ADDENDUM NO. 2

JUNE 8, 2017

**Tucson Airport Authority
Tucson International Airport
10112-254 Rehabilitate Runway 11L-29R and Connector Taxiways**

QUESTIONS/CLARIFICATIONS RECEIVED FOR PROSPECTIVE BIDDERS:

SHEET REFERENCE NUMBER:
G215
 SHEET 29 OF 410

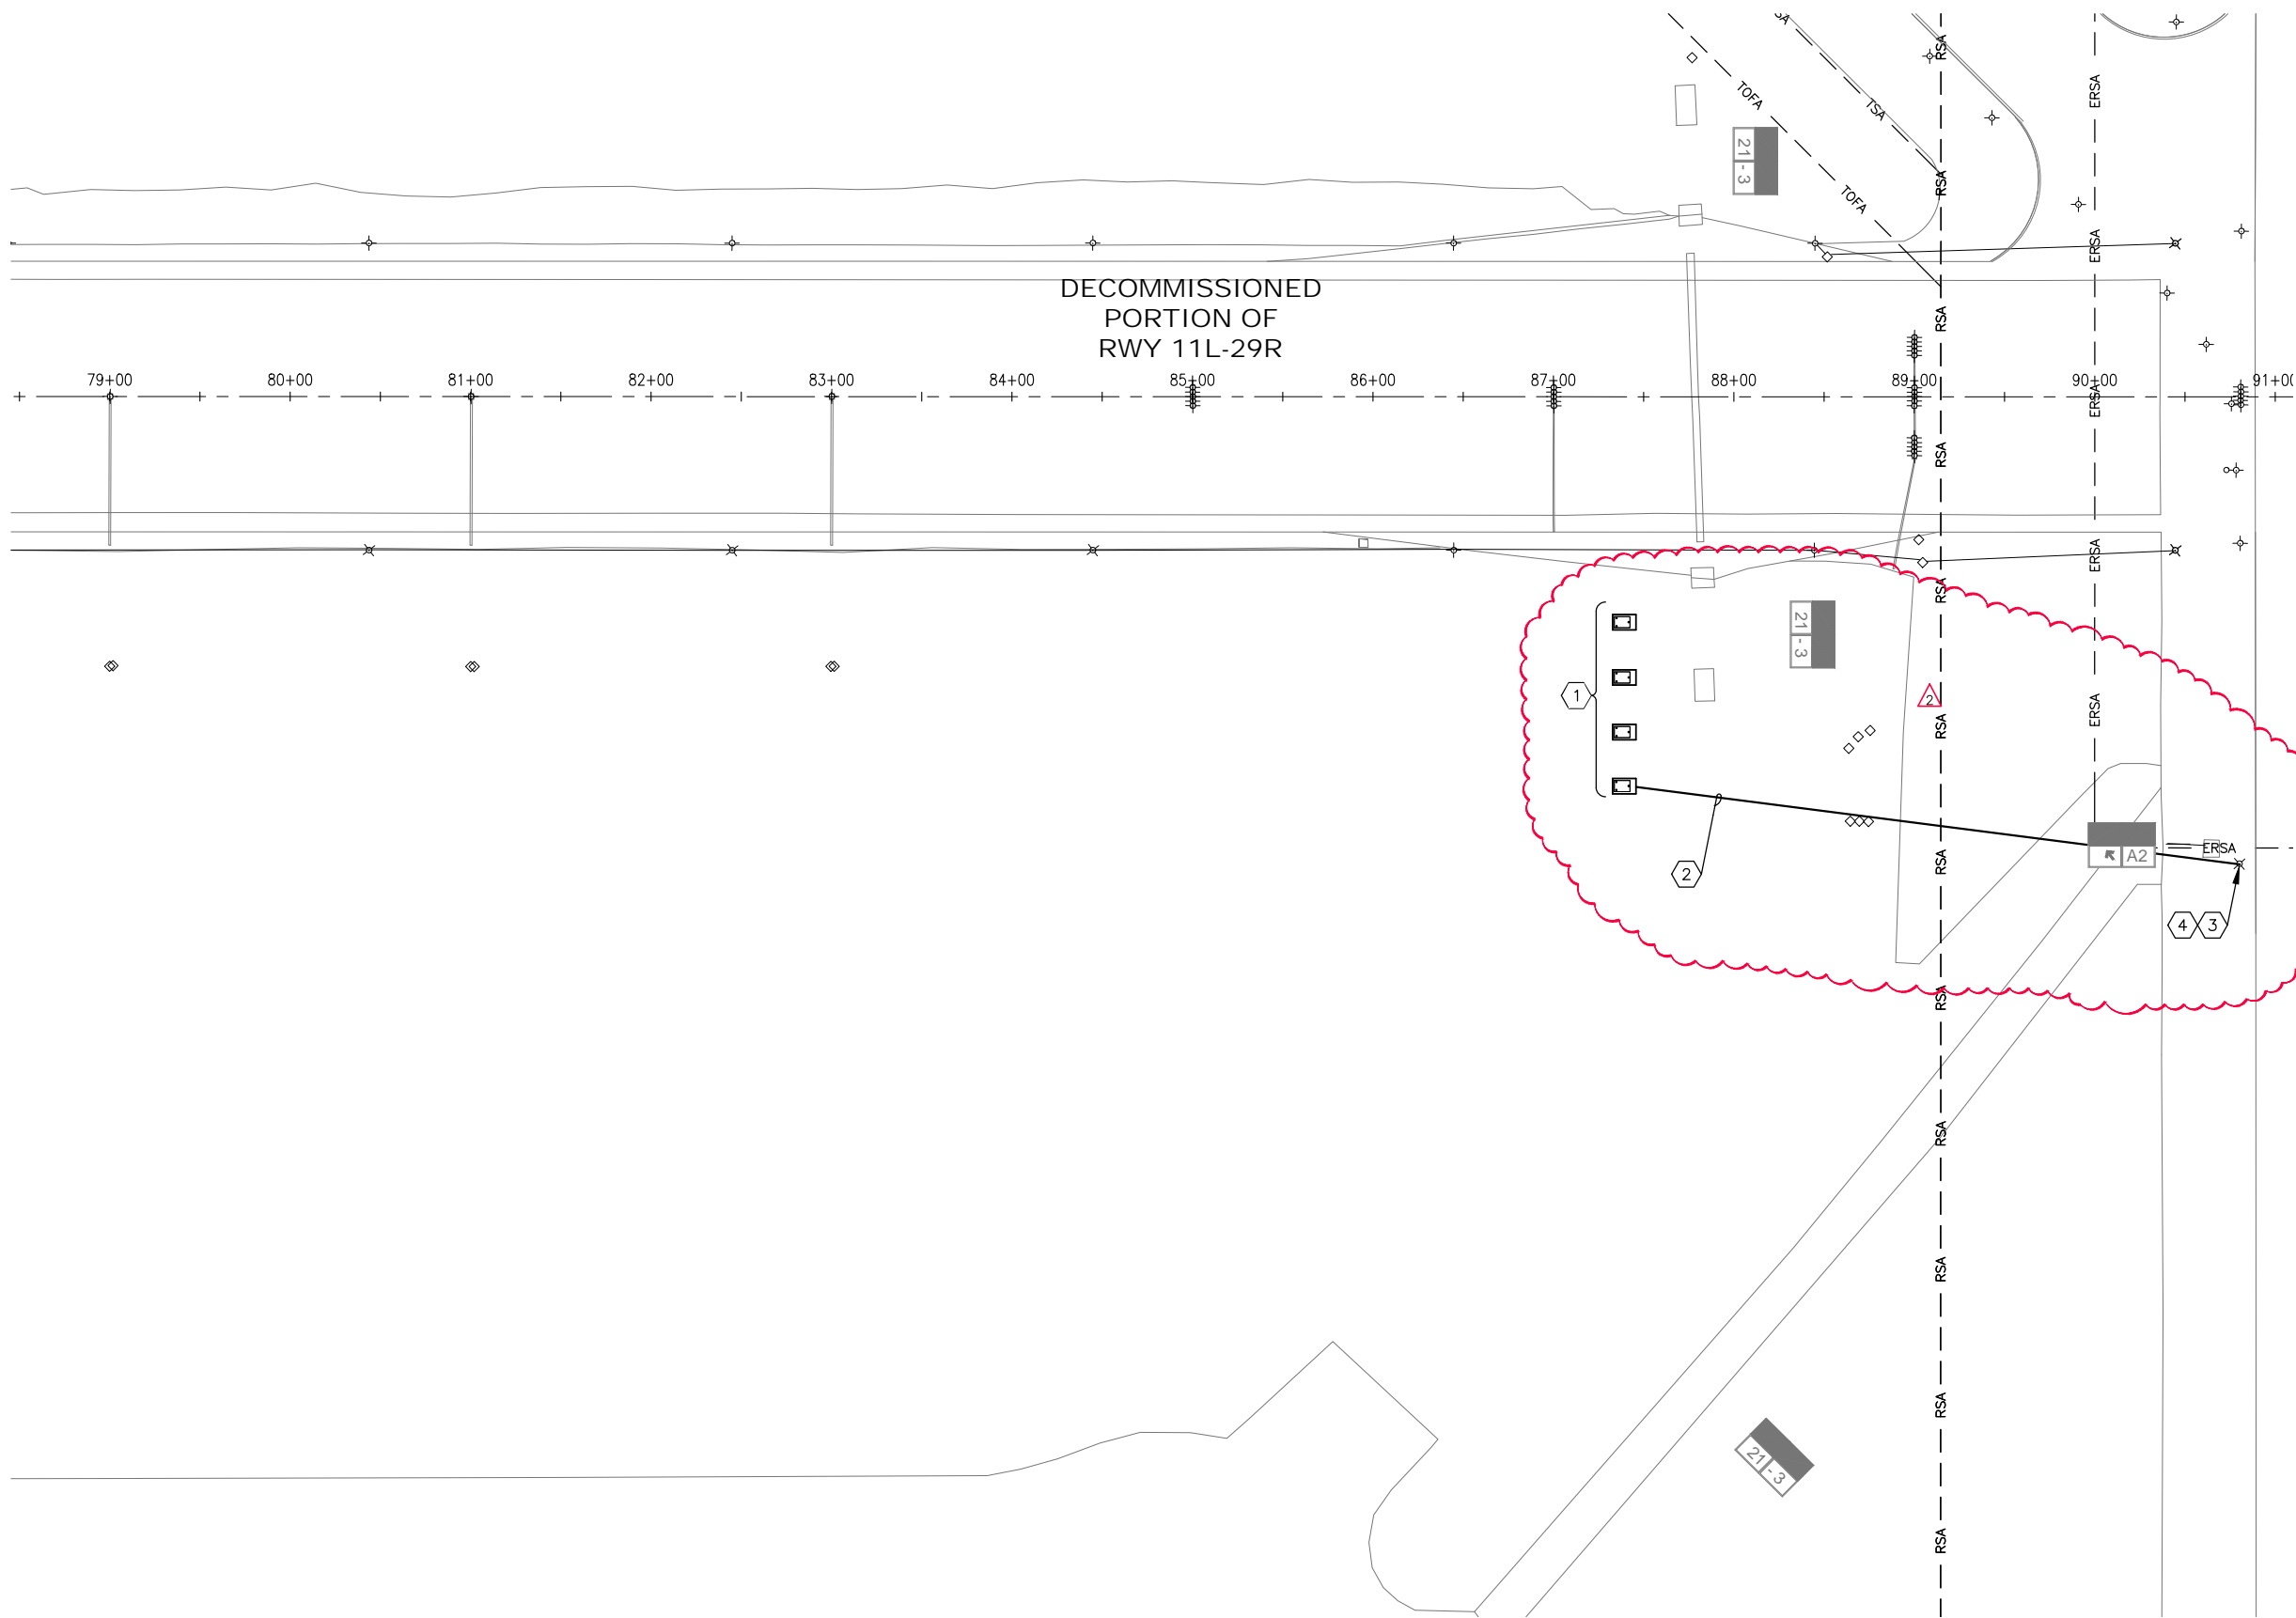
Sheet G215 PHASE 1D- TEMPORARY PAPI AT PHASE 3 RWY 11L THRESHOLD & TEMPORAY FLIGHT CHECK MARKING

SHEET REFERENCE NUMBER:
G218
 SHEET 32 OF 410

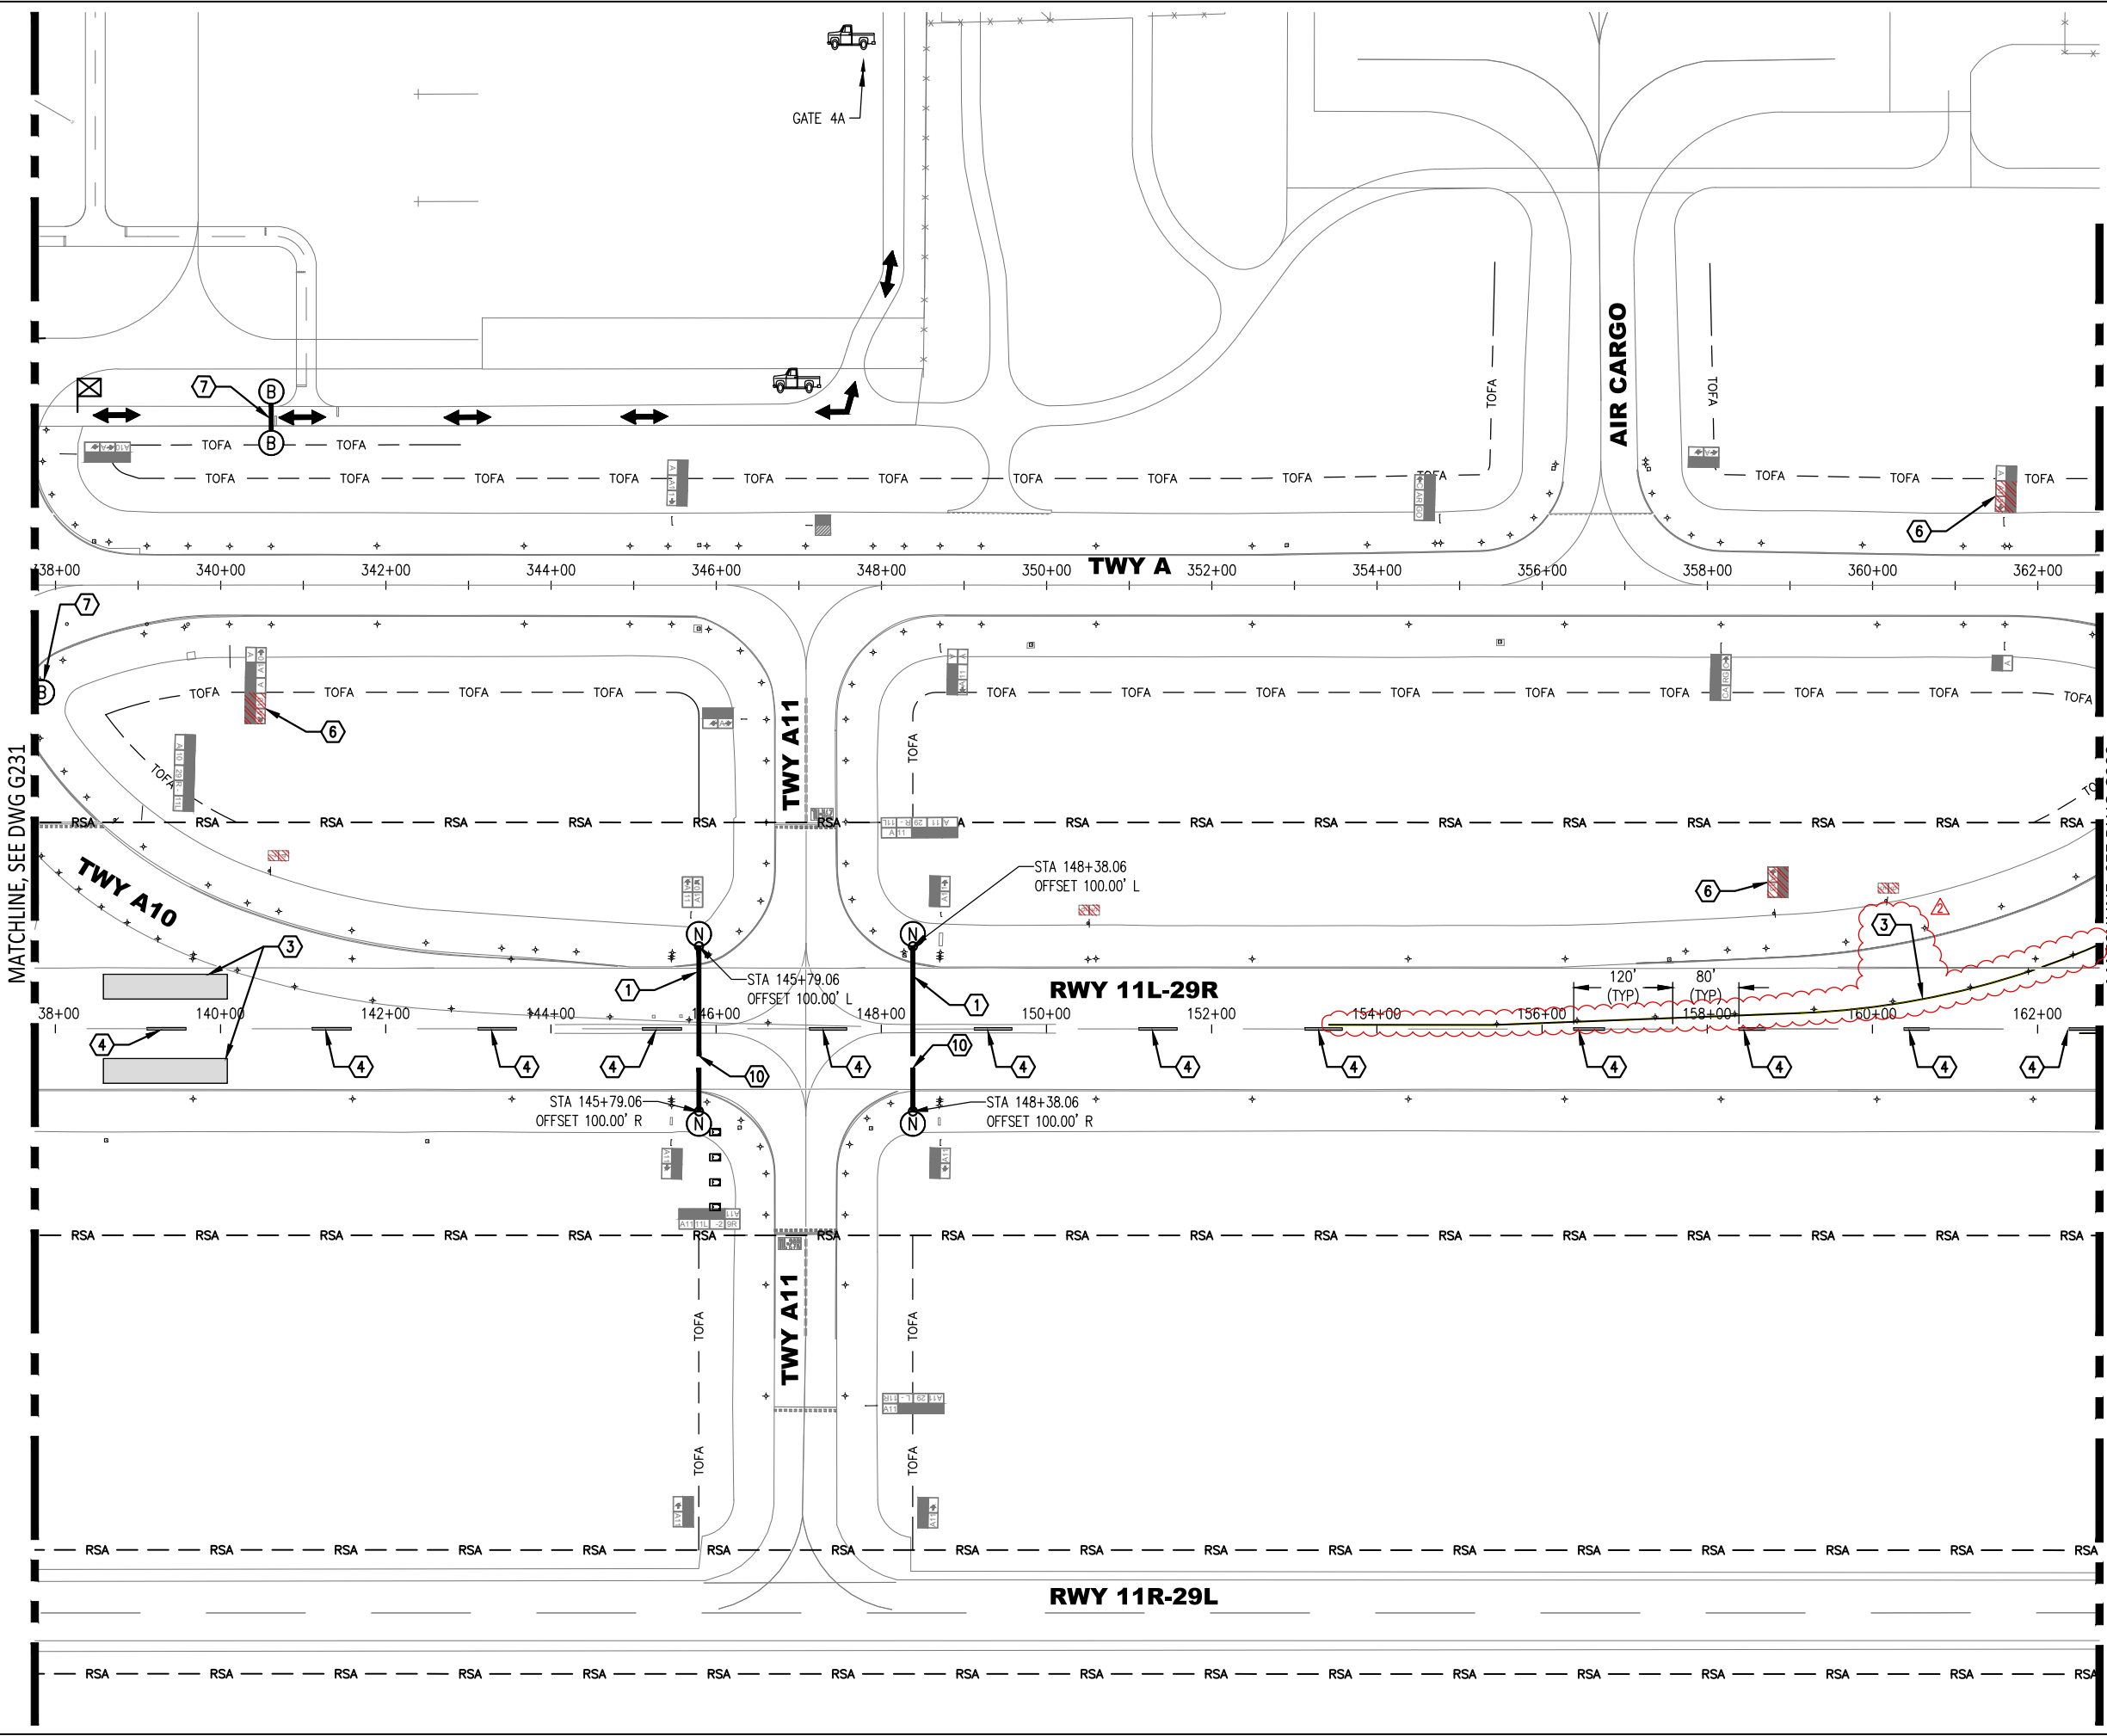
Sheet G218 PHASE 1D- TEMPORARY PAPI AT PHASE 3 RWY 11L THRESHOLD ELECTRICAL DETAILS

SHEET REFERENCE NUMBER:
G509
SHEET 140 OF 410

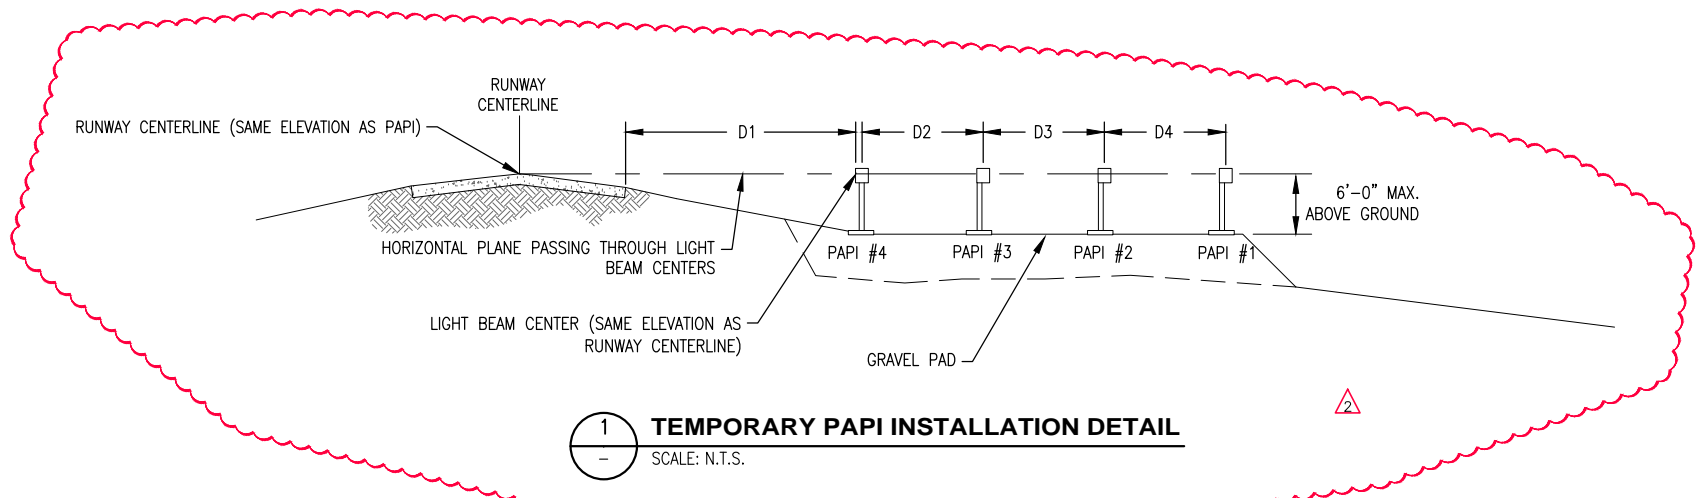
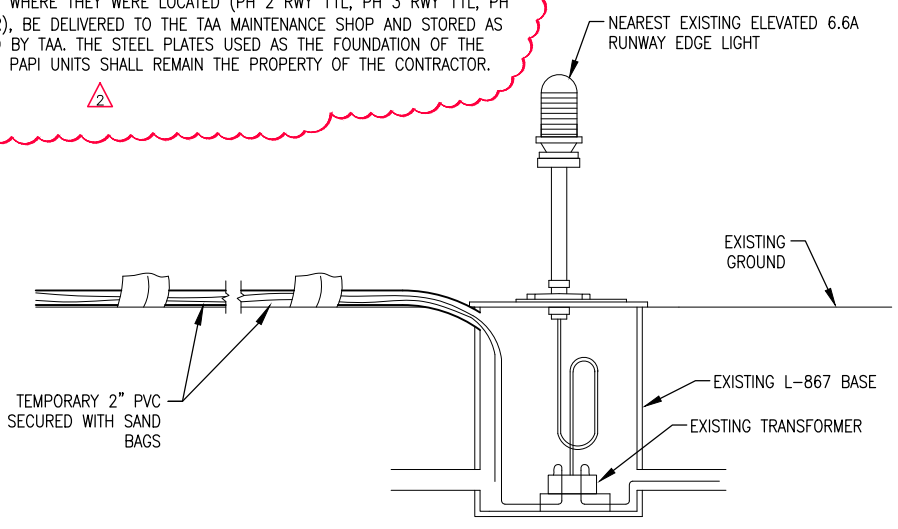
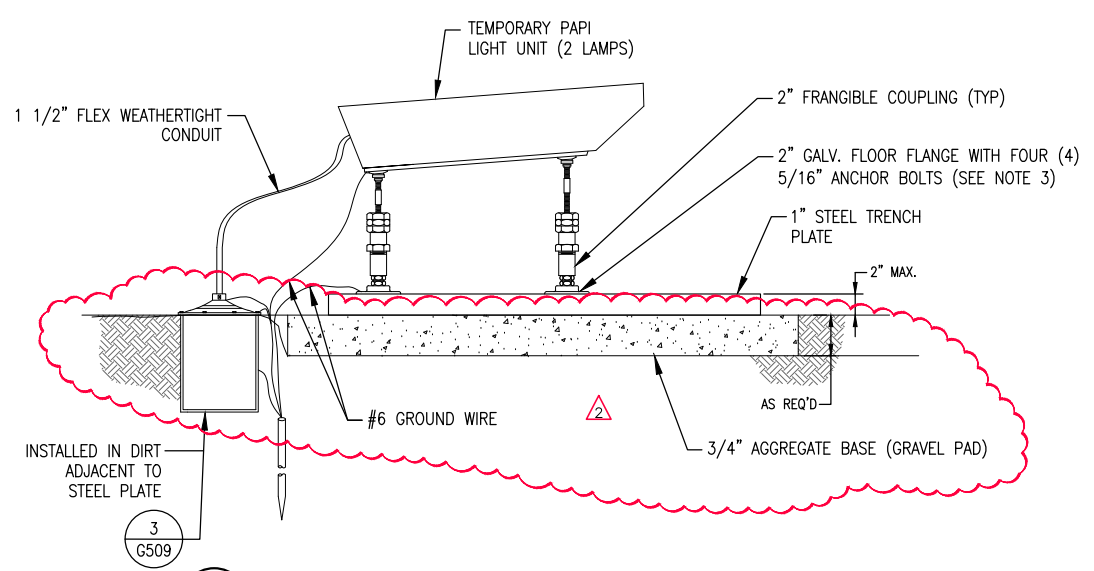
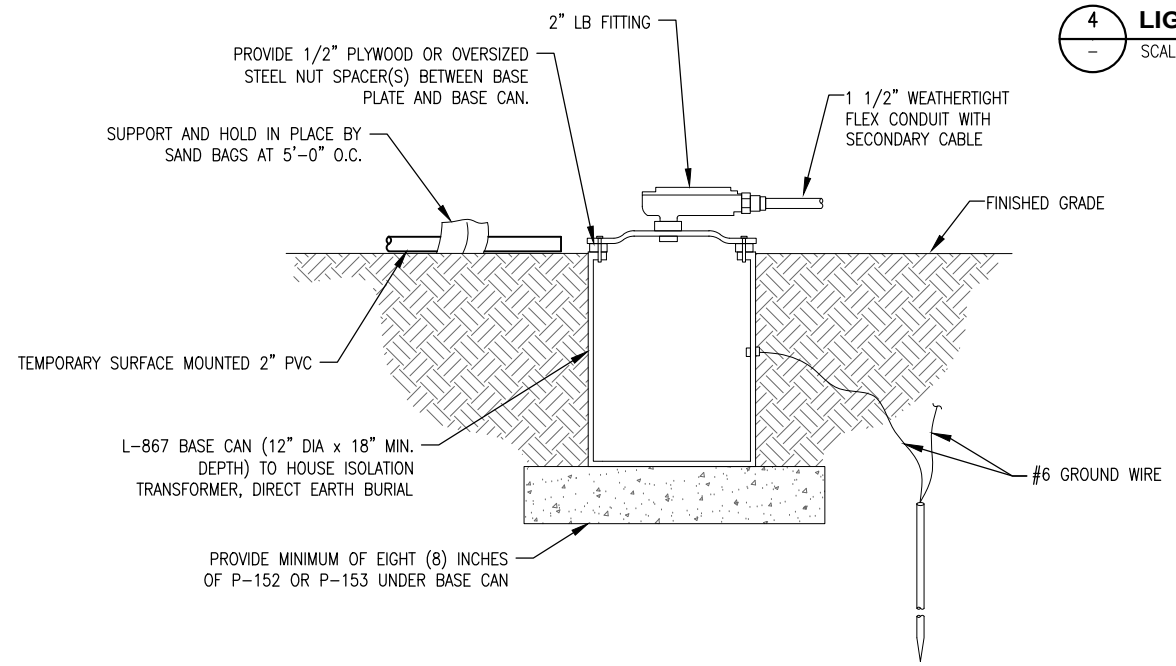
Clarification of Addendum 1 Pre-Bid Meeting Minutes and the question about the LED PAPI units. The L-880(B) 4-Box PAPI's are not LED PAPI's, the lamps shall be quartz lamps.

Sheet G509 TEMPORARY PAPI INSTALLATION DETAILS
